# Memorandum

Subject: **Response to public comments on the staff report titled *Assessment of Avian Mortality from Collisions and Electrocutions* (CEC-700-2005-015) (Avian White Paper) written in support of the 2005 Environmental Performance Report and the 2005 Integrated Energy Policy Report**

**Response to California Wind Companies (CWC) Comments Received on the  
Assessment of Avian Mortality From Collisions and Electrocutions  
(Avian White Paper)  
August 30, 2005**

**Figure 2-3.** Frequency distribution of types of injury attributed to wind turbine-caused fatalities among birds found in the APWRA.

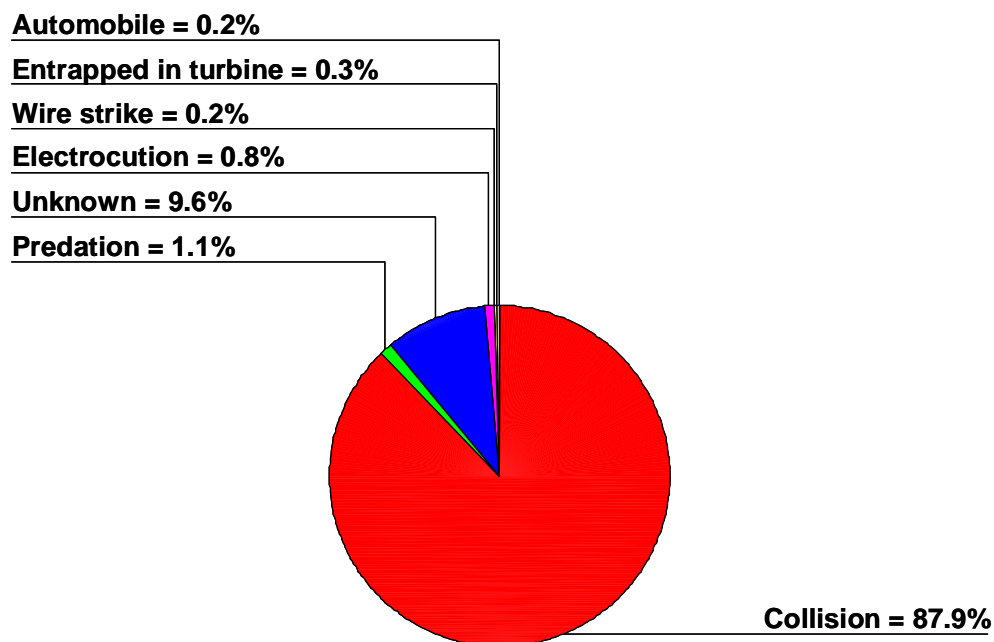
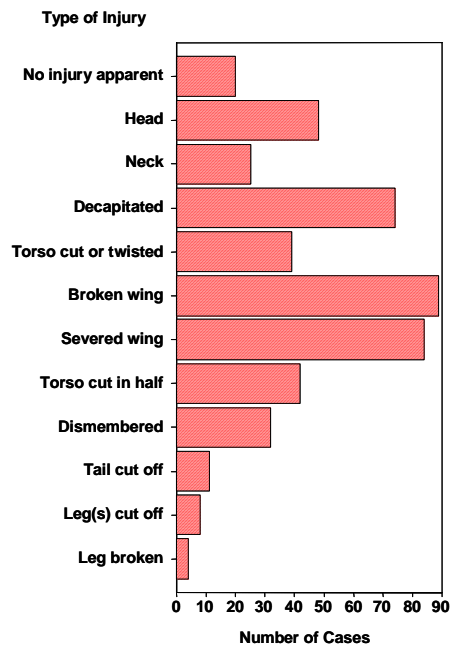
approximately 35% of juvenile golden eagles die in fledging accidents. Lifespan of golden eagles is given as approximately 20 years; ferruginous hawks have a similar lifespan. Of the total population of both species in the APWRA, 5% could be expected to die from aging each year in the absence of turbines. Approximately 8 – 10% of burrowing owls and American kestrels would also reach the ends of their lifespan each year. Hawks, eagles and owls in the APWRA prey upon each other and on other birds present at the site, which would contribute to carcasses with evidence of trauma. Hunt also reported golden eagle deaths from lead and pesticide poisoning and botulism. High avian populations in the APWRA should suggest the possibility of high background mortality, yet this was not considered in the avian mortality calculation. Although there are undeveloped areas of the APWRA with terrain similar to that containing turbines, these areas have not been searched to estimate the site's background mortality.

**Staff Response:** As Weisskopf points out in her comments Smallwood and Thelander (2004) did categorize the carcasses they found by what caused their death and the type of injury they had (pages 30-31, Figures 2-2 and 2-3 reproduced below). Although raptors do kill and eat each other, as Weisskopf says, the trauma evident on carcasses does not look like the types of injuries caused by wind turbines – severed wings, tails, and heads, and cut torsos. Birds that die of natural causes would also not exhibit the types of injuries that birds used in the analysis had and would be excluded from the analysis. Therefore, birds that die of natural causes may be in addition to the birds reported on in the 2004 Report but are not a subset of the bird deaths attributable to wind turbines, and therefore do not change the reported baseline data of birds killed by wind turbines.

Weisskopf also cites the golden eagle fledging accident rate of 35% (Hunt 2002), but the fledging eagles in Hunt's study area occurred in areas outside the APWRA. Whereas fledging accidents take a third of golden eagle juveniles, these accidents do not happen in the APWRA. Two of the dead golden eagles found in the APWRA that were reported in the 2004 Report (page 32) were electrocuted.

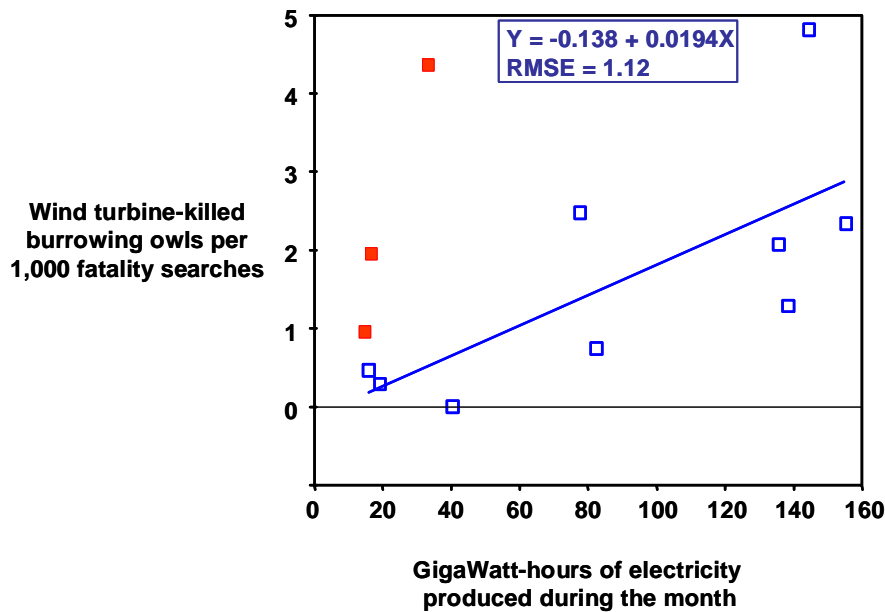
Weisskopf states, “This proposal [to shut down turbines during the winter] arises because studies have found that seasonal avian mortality is not correlated with wind power production.” In fact, see Figure 1 below for evidence that avian mortality is indeed correlated with power production during most of the year (using 1999 data from the APWRA in this case, which corresponded with the middle portion of Smallwood and Thelander’s study). And see Figure 2 below for evidence that the correlation between burrowing owl fatalities and power generation does not matter to the conclusion that a winter-time shutdown would make sense for burrowing owl.

**Staff Response:** In attempting to cast doubt on the efficacy of the proposed winter-time turbine shutdown, Weisskopf claims that there is an extensive literature on birds running into tall structures, suggesting that non-operating wind turbines will continue to kill birds. Staff has not found in the literature a source that reports golden eagles, red-tailed hawks, ferruginous hawks, barn owls, or great horned owls running into stationary tall structures. The extensive literature she refers to applies to migrating songbirds on the eastern seaboard of the US, and does not apply to the APWRA. Raptors are agile flyers with keen eyesight, and it is not common for them to run into stationary objects. Moving objects such as turbine blades and vehicles, however, are a well known fatality source for raptors.

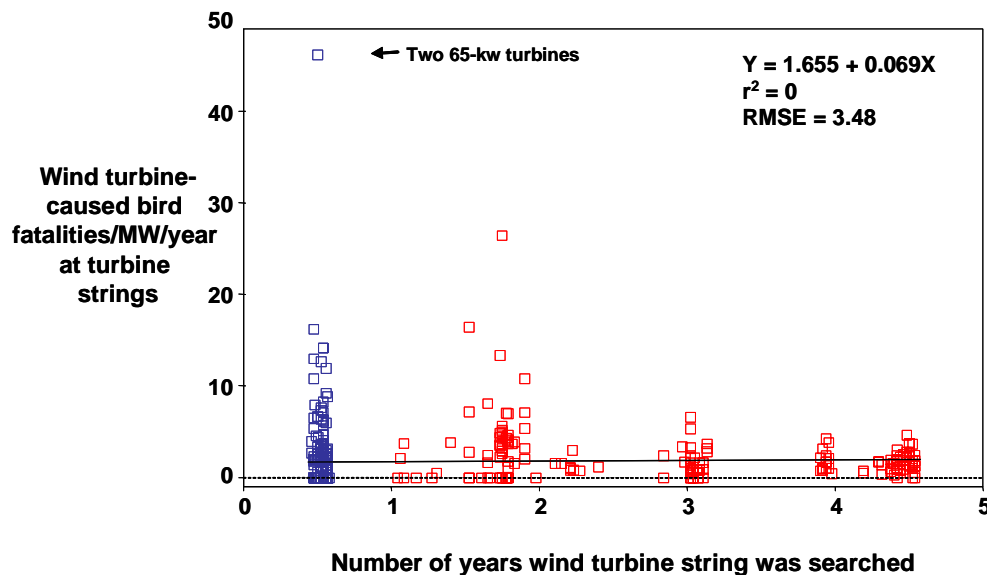
**CW-17:** In considering enacting recommendations or policy decisions for the Altamont Pass or for other wind resource areas, one should consider what is and particularly what is *not* known about avian interactions with wind turbines, and recall that in the APWRA a 71% reduction in estimated golden eagle mortality and a 100% reduction in estimated ferruginous hawk mortality could be achieved simply by omitting the second, flawed, turbine set.

**Staff Response:** See response to Comment CW-6. Smallwood and Thelander (2004) were up-front about the differences in Set 1 and Set 2 turbine fatalities. We agree that having access to the Set 2 turbines early and having more survey time on this set would enhance the results. Smallwood and Thelander stressed the need to have 3 years of monitoring data to make reliable estimates on mortality. The graphic below shows that less than 3 years of surveys likely under-represented the number of wind turbines associated with golden eagle and ferruginous hawk fatalities than if access had been granted sooner. The location of the Set 2 turbines was in an area identified by Hunt (2002) to have higher golden eagle use, and the type of turbines in Set 2 were considered more dangerous to golden eagles by Orloff and Flannery (1992, 1996). Therefore it stands to reason that these turbines would have a higher fatality rate than Set 1.

Fatality searches rapidly convert wind turbines in the 0-fatality category to the fatal turbine category through three years.

Study duration improved the precision of the mortality estimate through three years, while the mean mortality estimate did not change.

**Figure 2-3.** Frequency distribution of types of injury attributed to wind turbine-caused fatalities among birds found in the APWRA

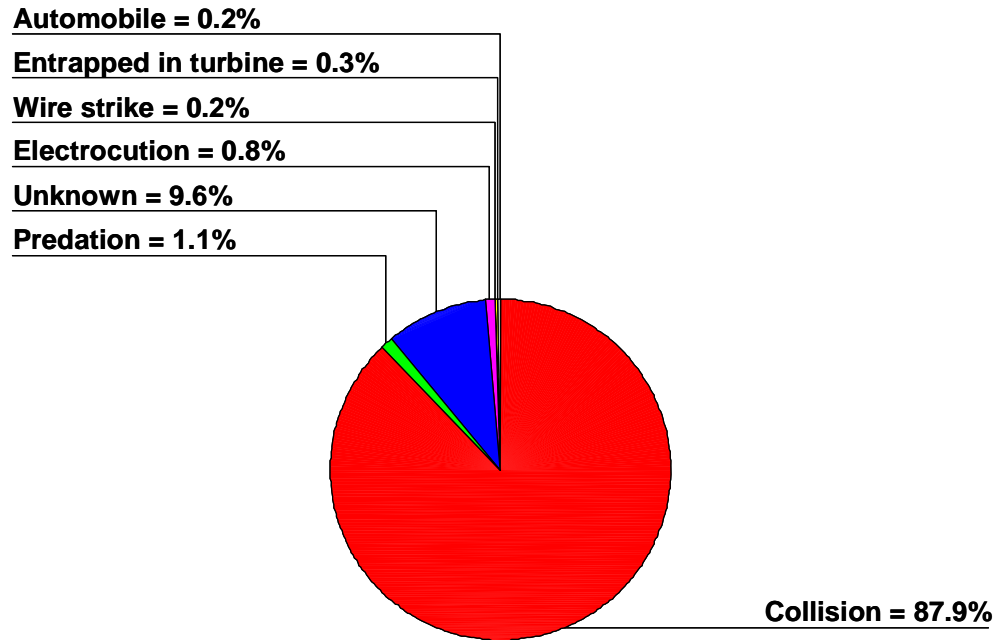
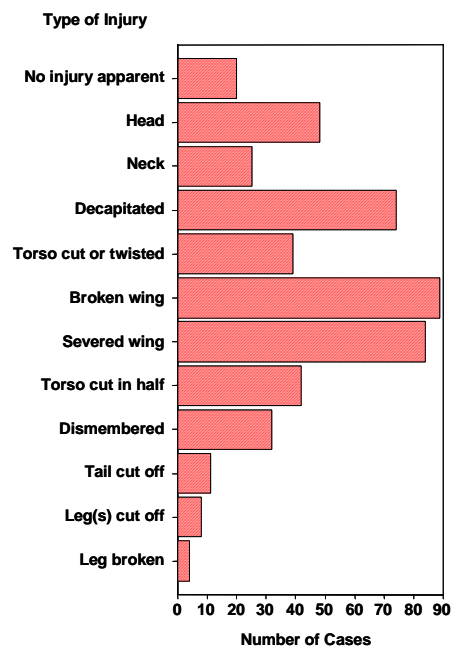
There is not extensive literature on raptor mortality with immobile objects – it is a fairly rare event. Raptors have keen eyesight and are very agile flyers. Passerines, however, are known to collide with communication towers, buildings, etc., particularly during mass migrations during inclement weather. In these cases, hundreds of birds may be found underneath the structure just after the weather event. Small birds also collide into windows of buildings, presumably because they do not recognize these reflective, stationary items as structures. Similarly, it is believed that raptors collide with moving turbines blades because they cannot see them until they are too close to avoid them.

Smallwood and Thelander (2004) distinguished death caused by wind turbines from other causes (see Figure 2-2 and Figure 2-3 below). Most carcasses had injuries that could easily be associated with turbine blade collisions, such as severed wings or tail, decapitation, or torso cut in half. A 2003 study conducted by WEST, Inc “Monitoring Studies at the Buffalo Ridge, Minnesota Wind Resource Area: Results of a 4-Year Study” found the amount of natural fatality occurring in their study was too small to warrant attempting to correct for natural mortality. Nor did it warrant the time required to document mortality in control (non-turbine) areas. Studies conducted by Anderson et al. in Tehachapi found those same results.

**Figure 2-9.** Frequency distributions of distance from the wind tower among carcasses of large-bodied (A) and small-bodied (B) birds species.

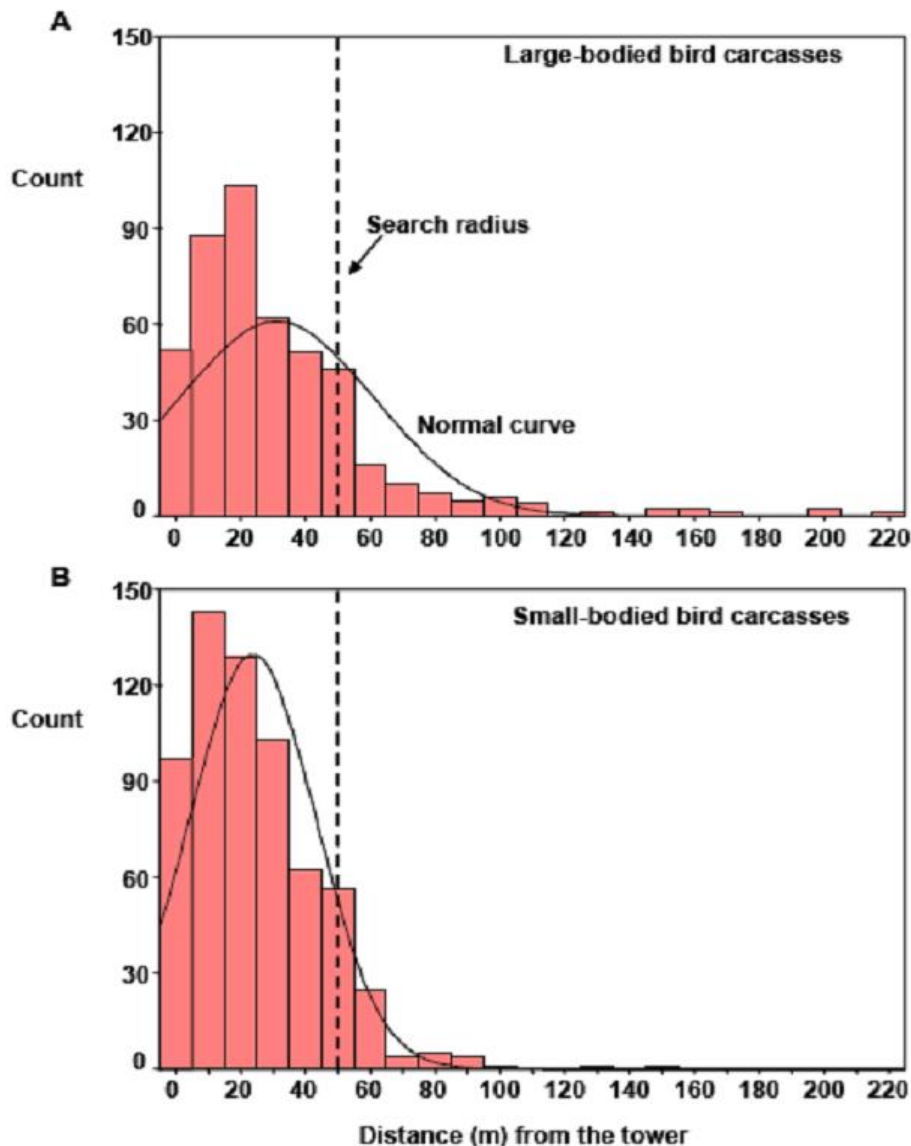
**RESPONSE:** The mortality estimates for bird species, including the brown-headed cowbird, were made only for bird species with more than one turbine-caused fatality. (see Methods section in Smallwood and Thelander 2004). Regarding the fact that some birds were found at a distance from turbines, Smallwood submitted to the National Renewable Energy Lab his eye-witness report of a rock dove struck by a wind turbine and thrown 50 m. The bird was still alive and flew away from the wind turbine another 150 to 200 m before it fell to the ground, where it was later found dead. Winkelman (1992) reported that 17 percent of collision victims were wounded but still alive. These are usually accounted for by another bias, crippling bias, which was not applied in the Smallwood and Thelander study, but would have resulted in higher mortality estimates. Feather spots are completely acceptable and standard evidence used for estimating the collision mortality (see attachments).

Weisskopf uses an outlier in her example. The vast majority of birds used in Smallwood and Thelander's analysis were found within 50-meters of the towers. For large-bodied birds, 84.7% of the carcasses found were within 50 meters. For small-bodied birds, 90.5% of all carcasses found were within 50 meters of the turbines (see Figure 2-9).
